ACCOUNT REFERENCE NUMBERS			
1002-2	02-295101	1002-3	02-295838
SHEET 1		CONRAIL CS-1002-A	
STANDARD MASTS FOR HIGHWAY CROSSING SIGNALS			
Approved: <i>P.H. [Signature]</i> Chief Engineer C&S			
ISSUE DATE: May 14, 1981			
REV. July 31, 1987

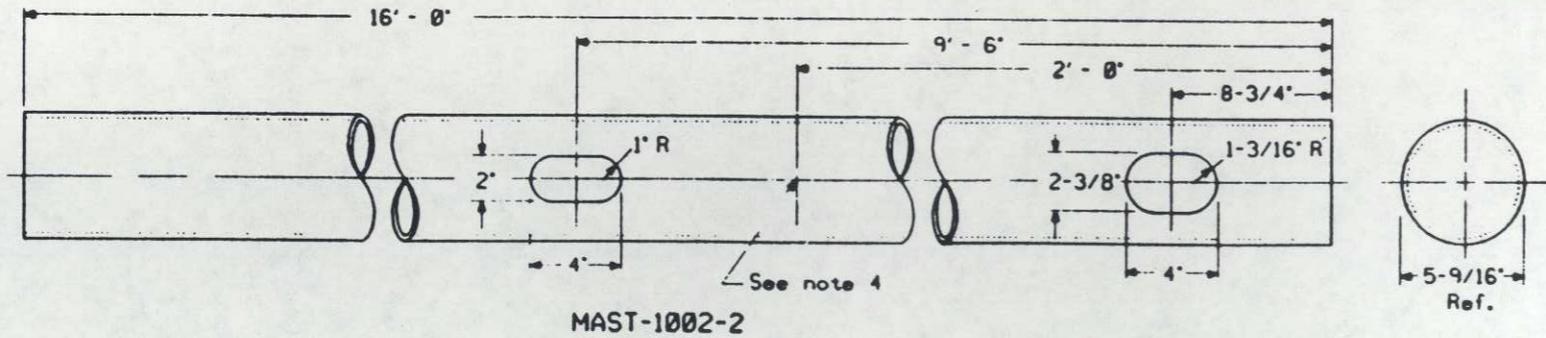
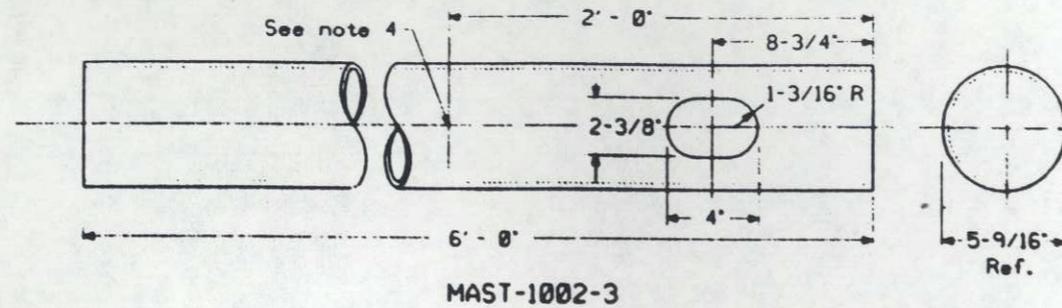
Rev. A 12-9-85: Removed  
 mast-1002-1. added  
 note 4.
